Product Change Notification

PCN-A-1050520

PCN Topic: Change the screw type and electric current of FM08/10 docking COM port

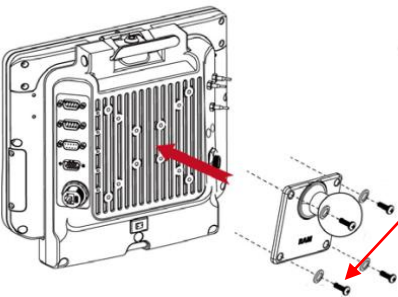
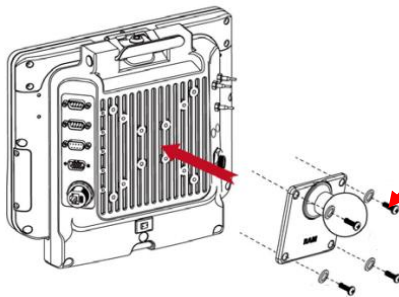
1. Change the screw type and length of Mounting Kit(no drill) from Big Flat Screw (M5 x 8mm) to Hex Socket Cap Screw (M5 x 12mm).
2. The electric current of FM08/FM10' COM port has been changed.

Original screws on the mounting kit (no drill)		NEW screws on the mounting kit (no drill)

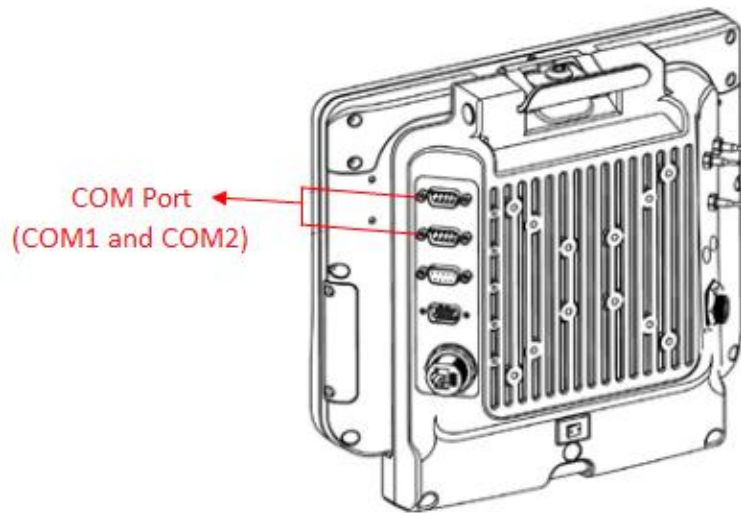
1. To screw the FM08/10 and docking on the vehicle tightly and make the machine more stable when the vehicle is moving, we change the screw type and length of the no drill mounting kits from Big Flat Screw (M5 x 8mm) to Hex Socket Cap Screw (M5 x 12mm).

Big Flat Screw (M5 x 8mm)		Hex Socket Cap Screw (M5 x 12mm)
	Part No: 913511101G0S		Part No: 913511101149
